COUNTY OF SAN MATEO PLANNING AND BUILDING DEPARTMENT

SUBJECT: EXECUTIVE SUMMARY: Consideration of a Certification of an Initial

Study/Mitigated Negative Declaration, a Coastal Development Permit, a Design Review, and a Certificate of Compliance (Type B) to allow construction of a new 2,200 sq. ft. single-family residence, on a 6,350 sq. ft. undeveloped parcel, located on San Carlos Avenue in the El Granada area of San Mateo County. This project is appealable to the

County File Number: PLN 2016-00011

DRAWING TITLE	DRAWN BY
	JZ
Northeast elevation	CHECK BY BONE Structure
SCEAU	DATE 2016/02/08
	SCALE As indicated
	REVISION 2
	A.202

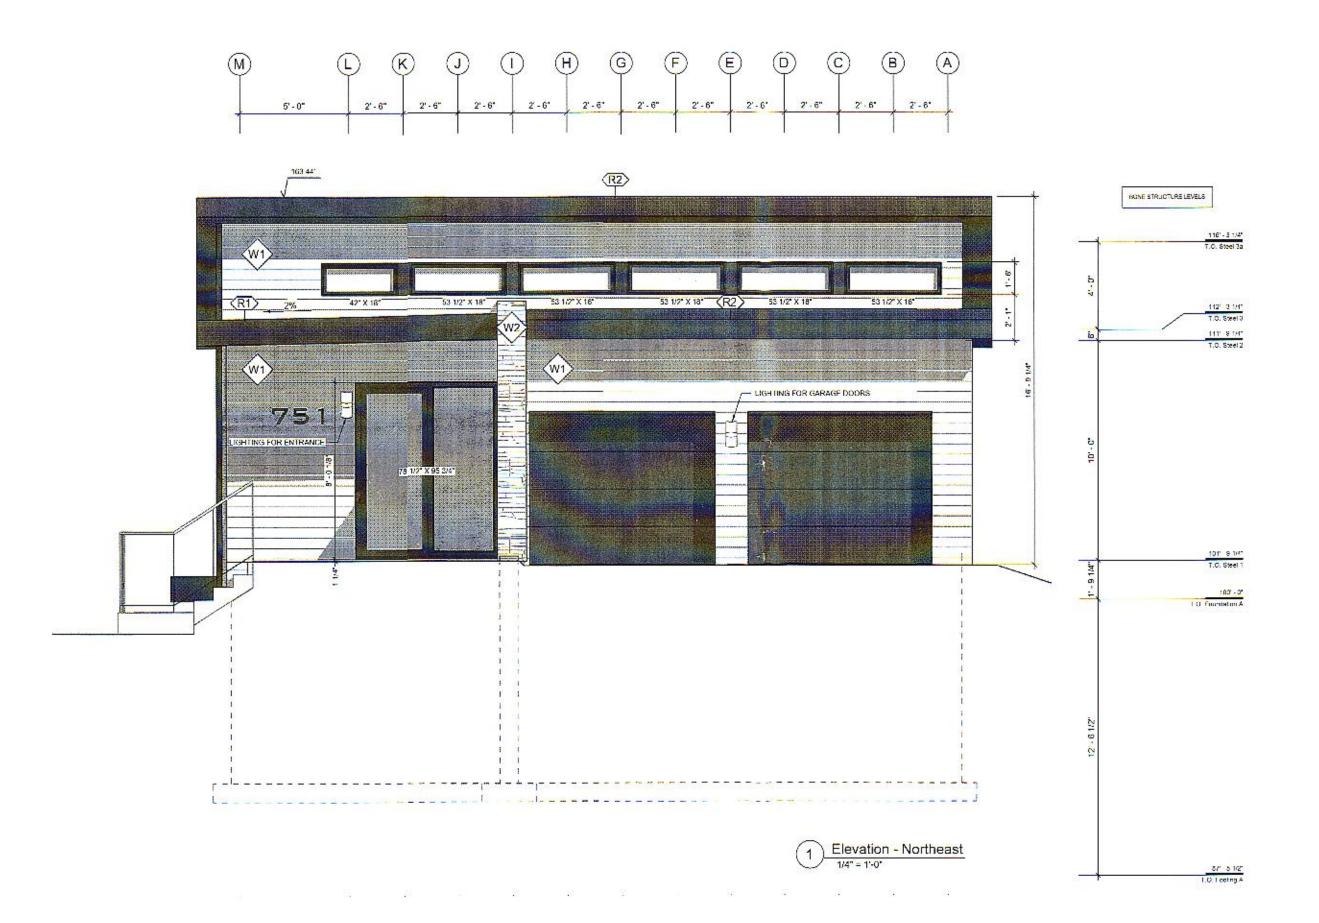
- a. Lower the rear plate height to 8' 6" with the slope of the roof to remain at the same angle.
 - b. Add a stone partial wall at the north side of the lower bedroom to extend up 6' above the upper deck floor for privacy.

- a. Lower the rear plate height to 8' 6" with the slope of the roof to remain at the same angle.
- b. Add a stone partial wall at the north side of the lower bedroom to extend upward, six feet (6') above the upper deck floor for privacy.
